Project Name : Posbrook Lane, Titchfield
Job No : 19-241
Note Title : Highways Response Technical Note
Author : MS
Checked : BM
Approved : BM
Date : January 2020

- 1.1 This Highways Response Technical Note (TN) has been prepared in response to comments made by Hampshire County Council (HCC) pertaining to the Outline Planning Application on Posbrook Lane, Titchfield (Ref: P/19/1193/OA); refer to **Appendix A**.
- 1.2 The site was subject to a previous Outline Planning Application (Ref: P/17/0681/OA) in 2017, which was refused and subsequently dismissed at Appeal. It should be noted though that there were no highways objections raised as part of this application and that the access proposals being submitted as part of the current application are the same as those for the Appeal scheme.

Job Title	POSBROOK LANE, TITCHFIELD	Scale	1:500@A3	Date	JAN 20	Designed	MS
Drawing Title	SWEPT PATH ANALYSIS - LARGE TIPPER	Drawn	MS	Checked	MS	Approved	BM
Client	FOREMAN HOMES	Job No	19-241	Drawing No	19-241/006	Rev

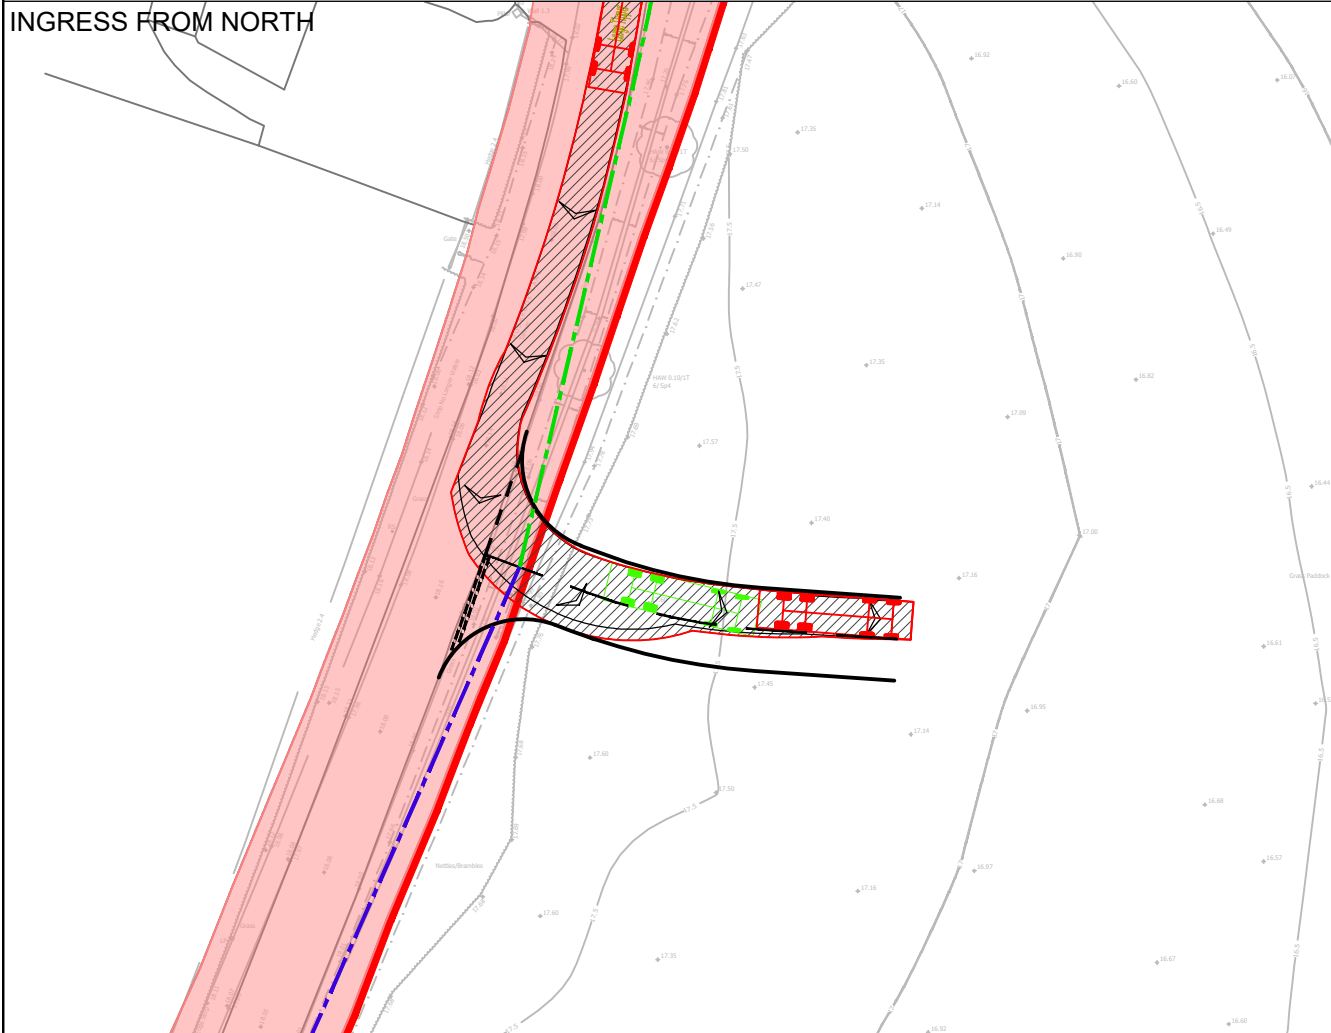
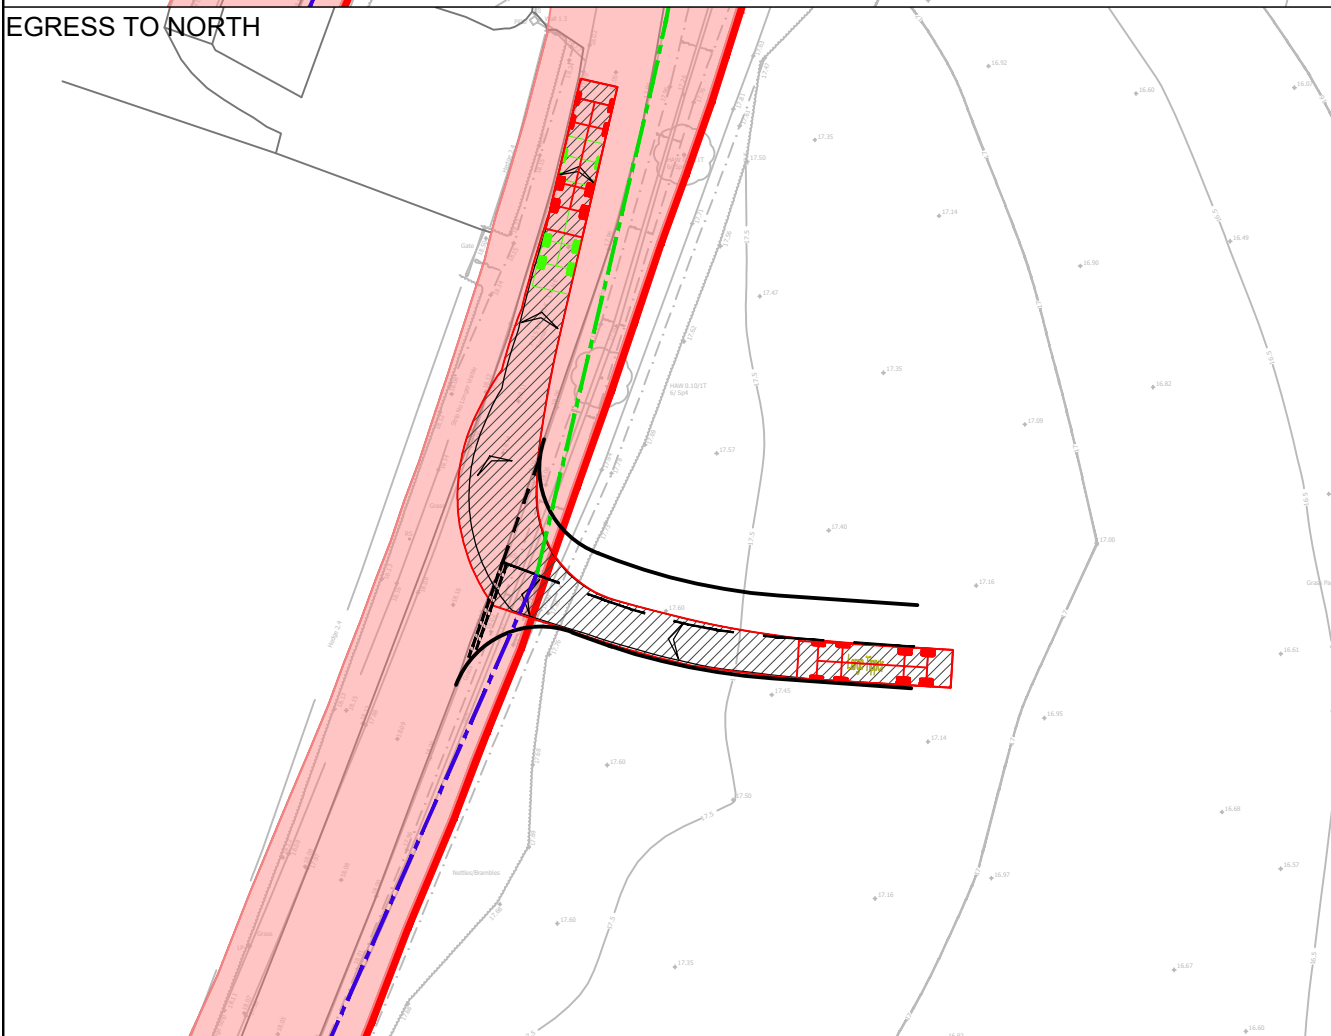
“With regards to vehicle tracking, a super large refuse vehicle should be used (11.m long x 2.53 wide) plus an artic lorry as it is assumed that the access will be used for construction traffic.”

2.8 It is considered that a Large Tipper will be the worst-case vehicle to access the site at the construction phase of the development. These movements are shown on **Drawing 19-241/006**. Furthermore, the maximum vehicle size can be conditioned as part of any planning approval.
